CPC TRANSMITTAL & SUMMARY SHEET
CITY OF RIVERSIDE PLANNING DEPARTMENT

Project Description: PLANNING CASE P04-0486: Proposed plot plan review by PBS&J on behalf of Peninsula Retail Development for a new commercial and retail development on approximately 6.1 vacant acres, situated at the southwest corner of Bountiful Street and Trautwein Rd, in the C-2-SP – Restricted Commercial and Specific Plan (Orangethills) Combining Zones.

Case Number: P04-0601 (Modification of Conditions for PM 30369)

Case Number: P04-0486 (Plot Plan Review) PLANNING COMMISSION HEARING DATE: July 8, 2004

ORANGECREST COMMUNITY CENTER PHASE II Plot Plan / Conceptual Grading Plan

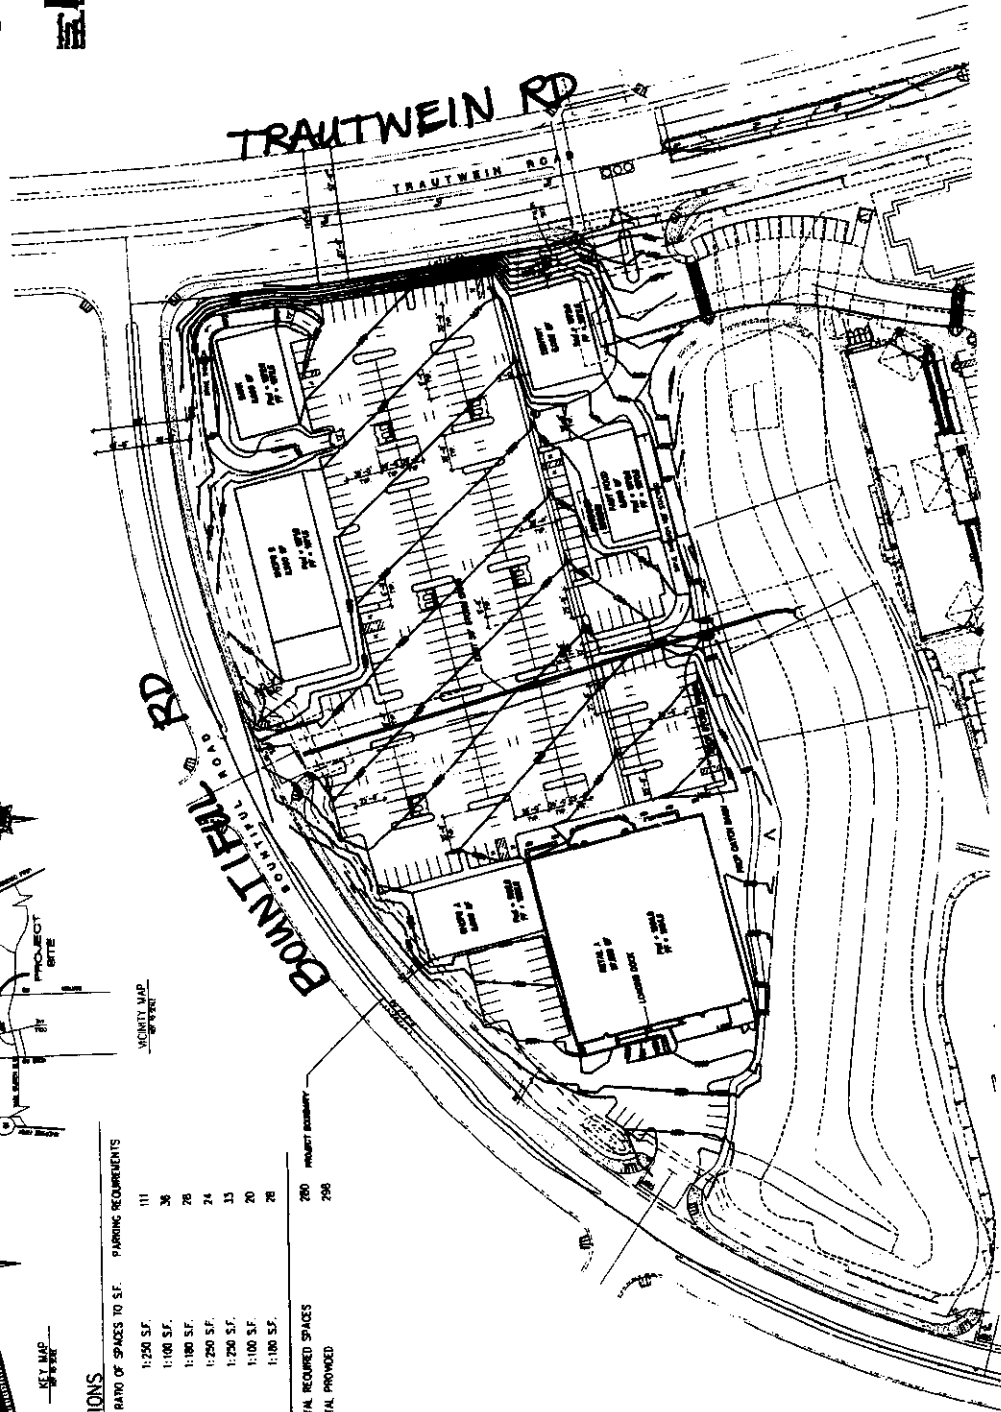
- *18. The plot plan submitted for Design Review Board approval shall be revised to incorporate the following changes:
 - a. Pedestrian walkways through the center linking the proposed buildings and including trellises and pedestrian furniture;

- b. The areas on Parcels 6 and between the buildings and the riparian area of Parcel 7 should be designed with a strong pedestrian oriented relationship with the riparian area, including such amenities as outdoor dining areas;

- c. The walkway along the riparian area should include trellises and benches.
 - d. A pedestrian bridge connection should be made through/over Parcel 7 and the riparian area, connecting the two sections of the commercial center.

- e. The riparian area should be enhanced in accordance with the requirements of the U.S. Army Corps of Engineers and should be enclosed within and six-foot high wrought iron view fence.

- *6. The plot plan shall be revised to show a pedestrian walkway connecting the northerly buildings to the southerly portion of the project. The connections should included decorative hardscape and landscaping.

11. The plot plan shall be revised to show a pedestrian walkway connecting the northerly buildings to the southerly portion of the project. The connections should include decorative hardscape and landscaping.
12. Provide a bermed landscape planter along Trautwein Rd and Bountiful Street in order to better screen the drive-thru lane.

Commissioner Leonard asked if there was a plan to screen the trash enclosures.

Commissioner Brown stated he was not signaling out this project, just stating his opinion. He said it would be nice to have a fountain at the center of the parking lot instead of a trash enclosure. The Commission should start doing something other than rubber stamping every new shopping center and add some class. He addressed staff and stated that he would prefer to see the trash enclosures removed and perhaps a fountain that would draw people to it instead of the usual rubber stamp approach to shopping centers.

Mr. Ewing stated that the enclosures were located to provide a central location for the tenants. The objective was to minimize the number of overall trash enclosure. They do have some flexibility in where they are located and would be willing to work with staff on the location. Again, with the screening, he thought the aesthetic impact would be significantly mitigated.
